**PLANNING COMMISSION
STAFF REPORT**

February 15, 2018

AGENDA ITEM: Planning File No. 297-17-DA: A Development Application review of the proposed Vistas on Granite Street multi-family residential project

LOCATION: 317 Granite Street / Lots 21-24, Block 9, Frisco Townsite

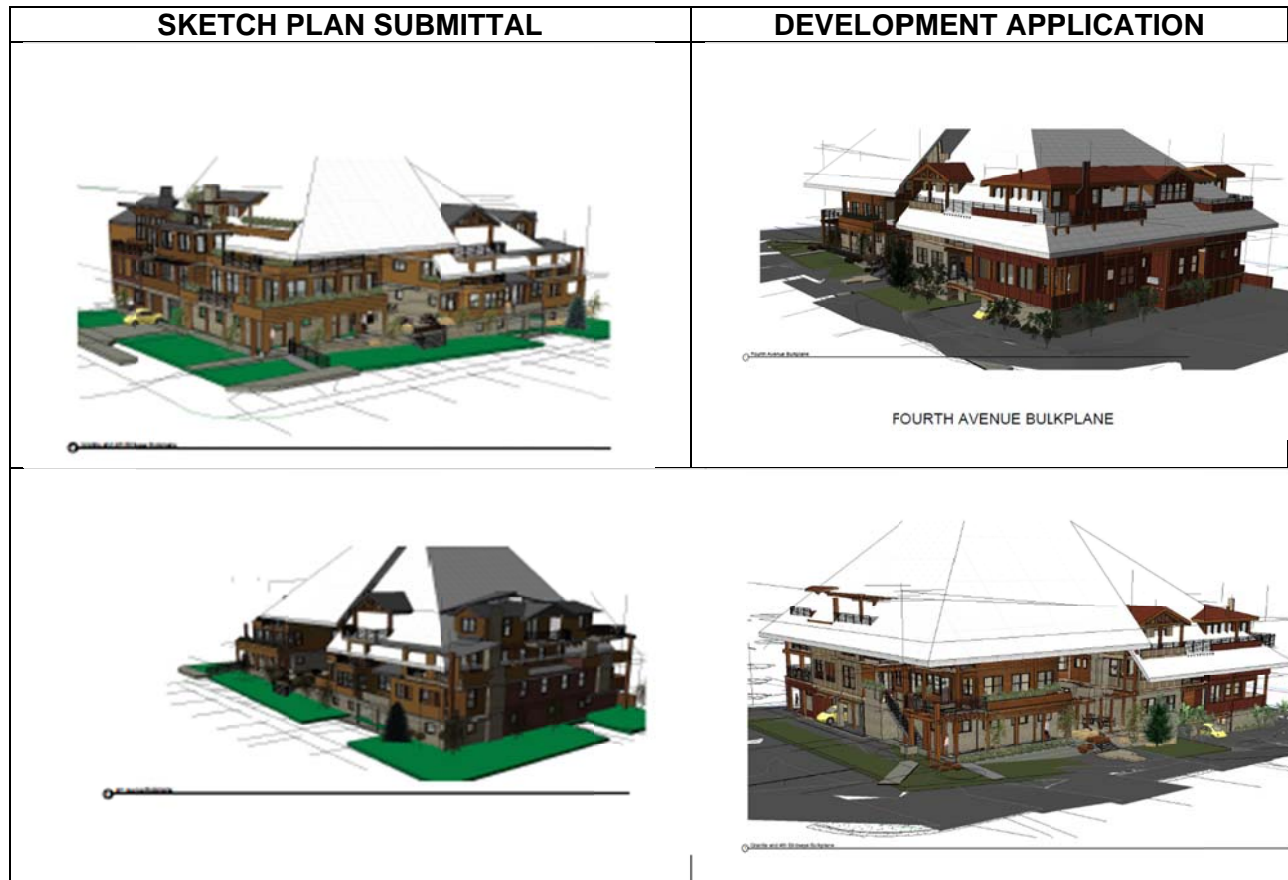
Elements of the proposed Vistas on Granite Street building deviate from the bulk plane envelope standards prescribed in Standard #2.4 of the Granite Street and Galena Street Overlay District. Building forms may project beyond the bulk plane if the Planning Commission finds that the forms comply with the building height limits and "provide substantial architectural

relief". At the August 3, 2017 Planning Commission meeting, the Planning Commission provided general feedback that they had concerns with the proposed bulk plane encroachments. As can be seen in the comparison below, the applicant has reduced the bulk plane along the South 4th Avenue and increased the bulk plane along Granite Street.

Staff believes that there is too much building mass outside of the bulk plane limits beyond what the criteria allows and the reasoning for when an encroachment may be allowed by the Commission – that being “architectural relief” that enhances the design. Our observation is that the encroachments actually detract from the overall design by creating more of a looming facade over the streetscape. Staff does not think that the bulk plane encroachments provide substantial architectural relief and recommend that the encroachments be further minimized. Should the Planning Commission find that the encroachments provide substantial architectural relief and advance the intent of Goal #2, then the application meets this standard.
